# P802.1Qbe Draft 1.2 issues

**Version 1**

**Norman Finn**

# Where else? Option 1: All PNPs

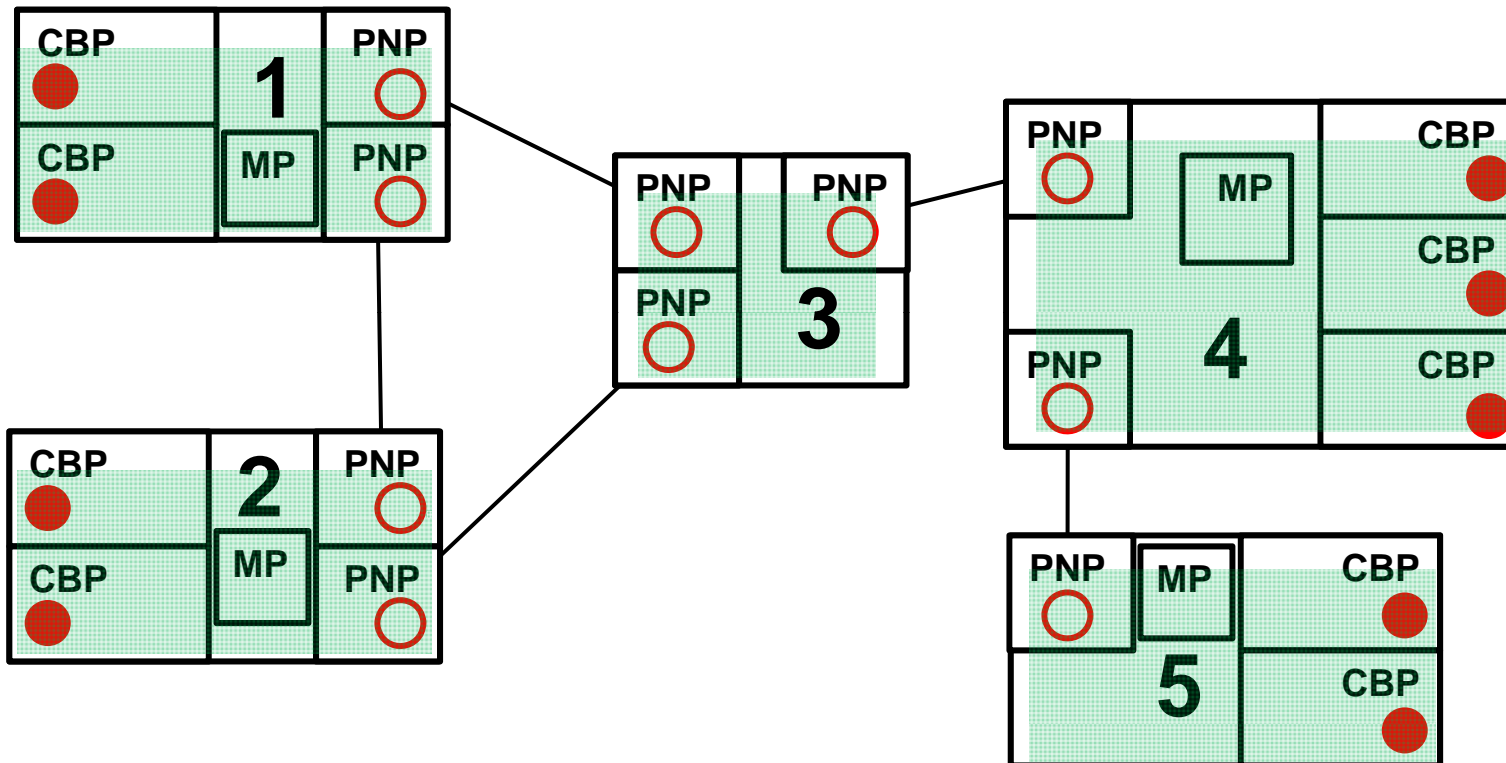
- (MIRP MAP shown shaded)
- **PROBLEM:** Bridge 3 has millions of state machines it doesn't need, as may the lower-left PNP on Bridge 4.

## Where else? Option 2: One PNP

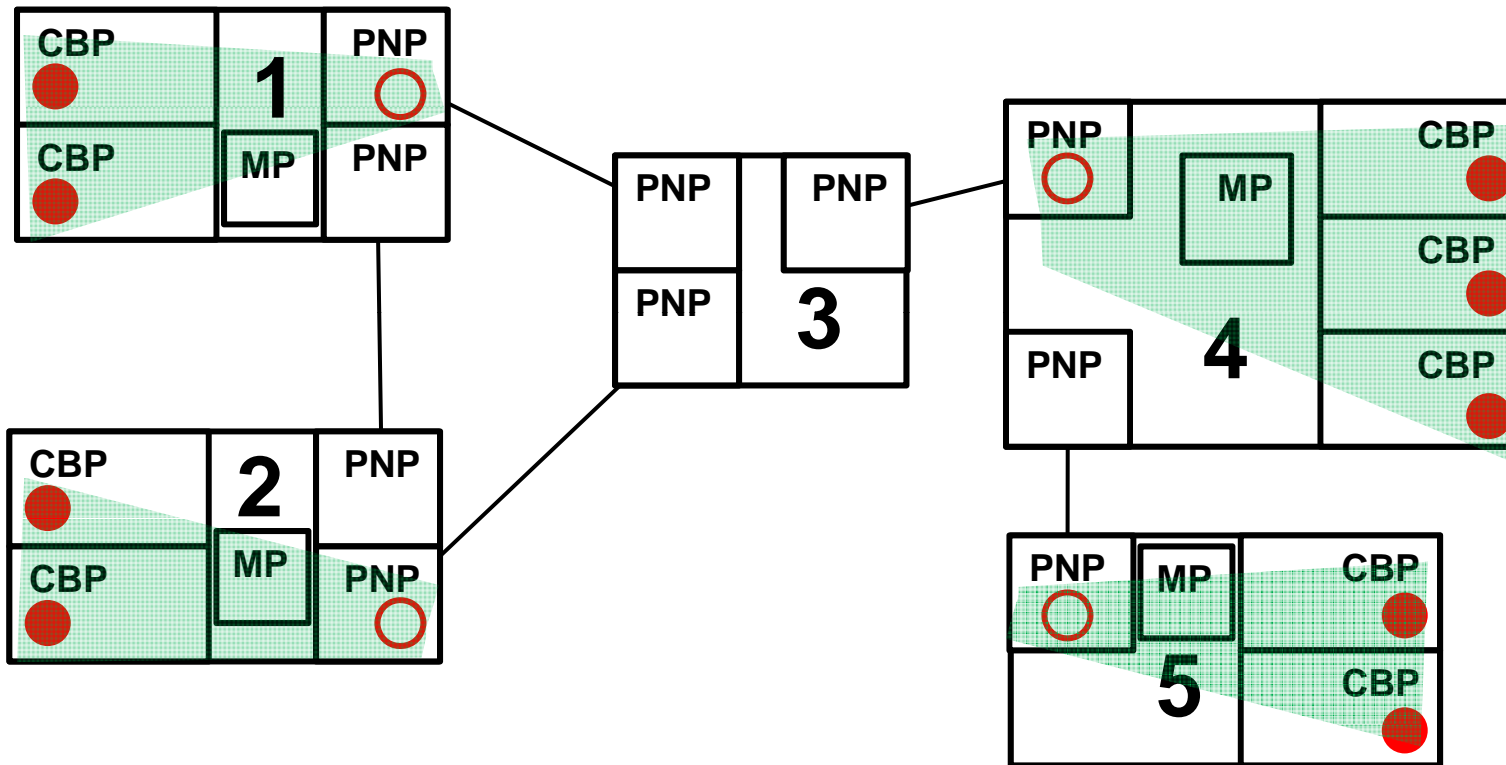
- **FIX:** No MIRP state where not needed
- **PROBLEM:** Every circled PNP must subscribe to every B-VLAN and every Multicast address used for data!

# Where else? Option 3: Maintenance Port

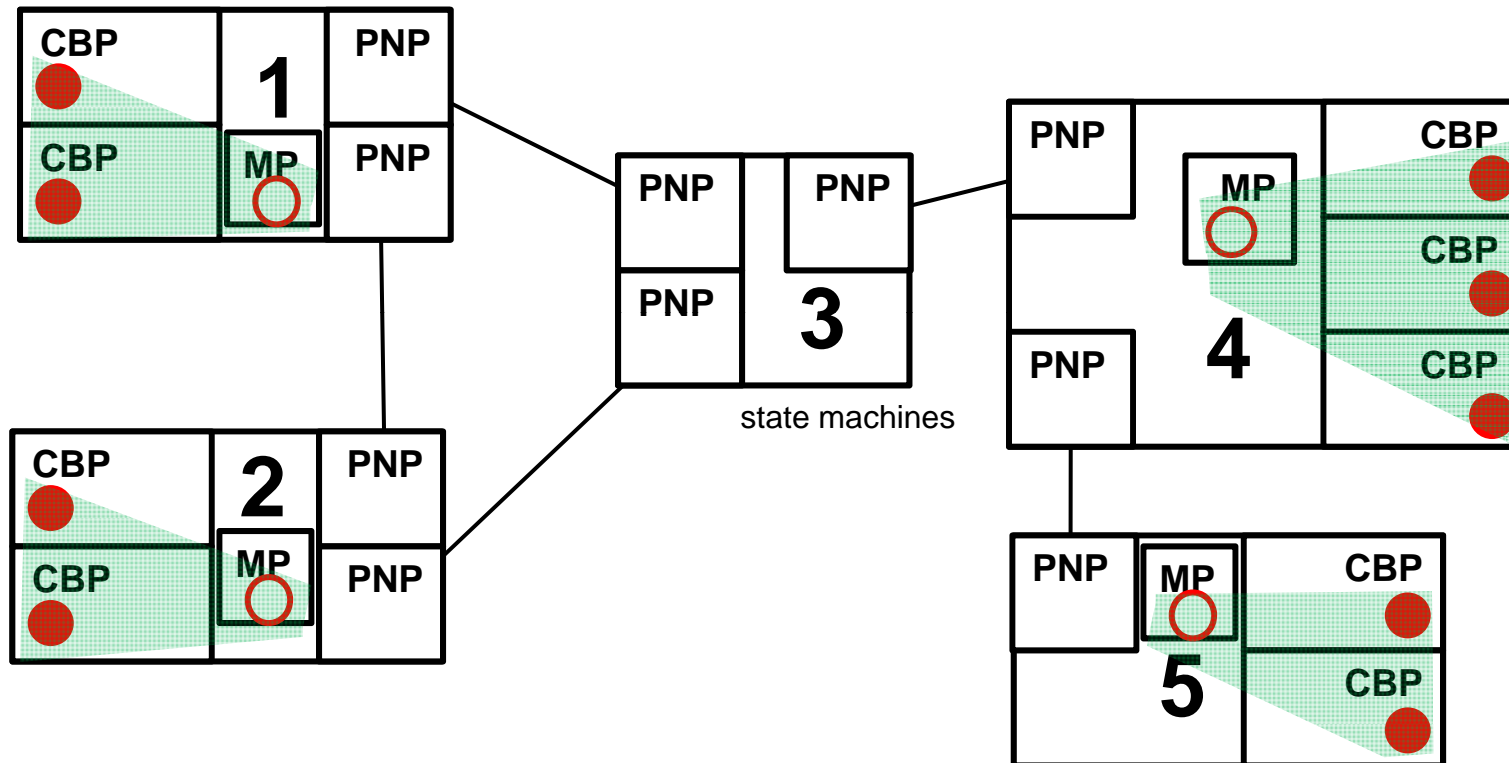
- **FIX:** No MIRPDUs where not needed
- **PROBLEM:** Management Ports must have multiple overlapping contexts and access CBP's configuration.

## Where else? Option 4: CBP only

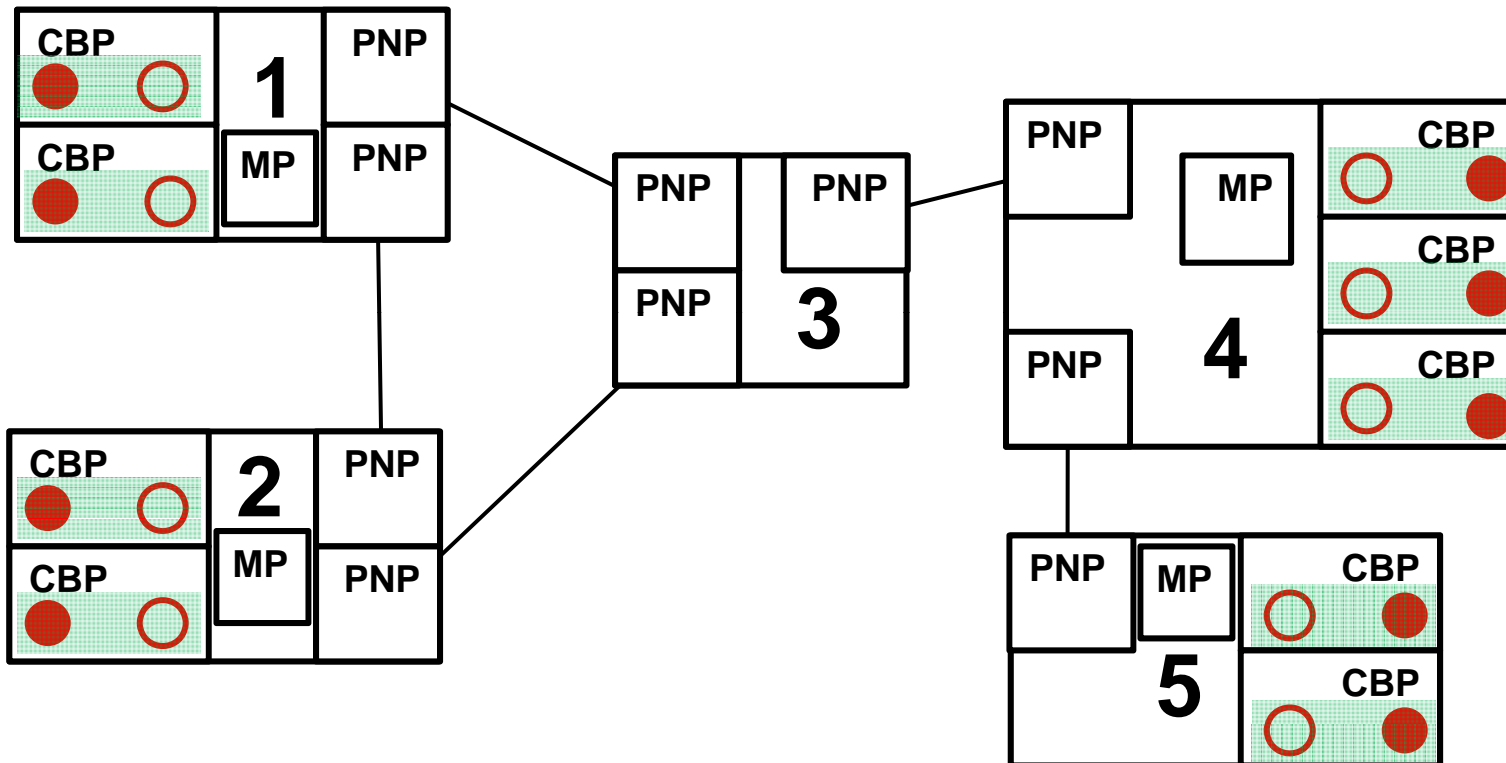
- **FIX:** Only local information needed, no context ID
- **PROBLEM:** CBPs apparently communicate via MIRPDUs even within a chassis.

## Similar for CBP-only option

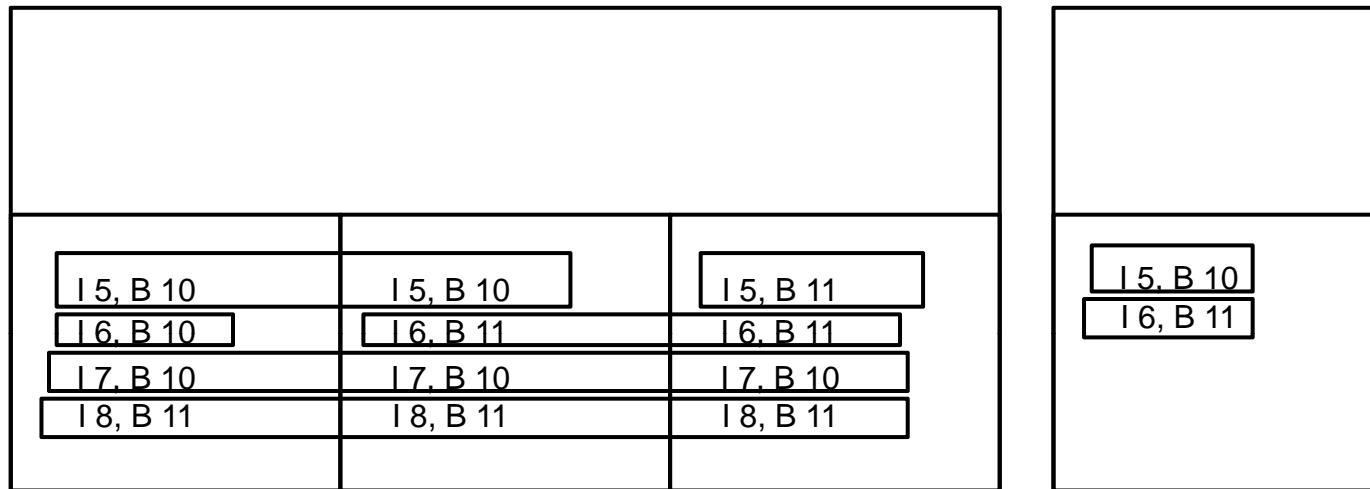
- Problem on previous slide does not exist in CBP-only.
- However, a similar problem can arise in the case above. If the right-hand bridge sends one MIRPDU for I5 and I6 in the MIRP B-VID, this will be accepted by all of the CBPs in the left-hand bridge, and result in the unwanted flushing of {I5, B11} and {I6, B10}.
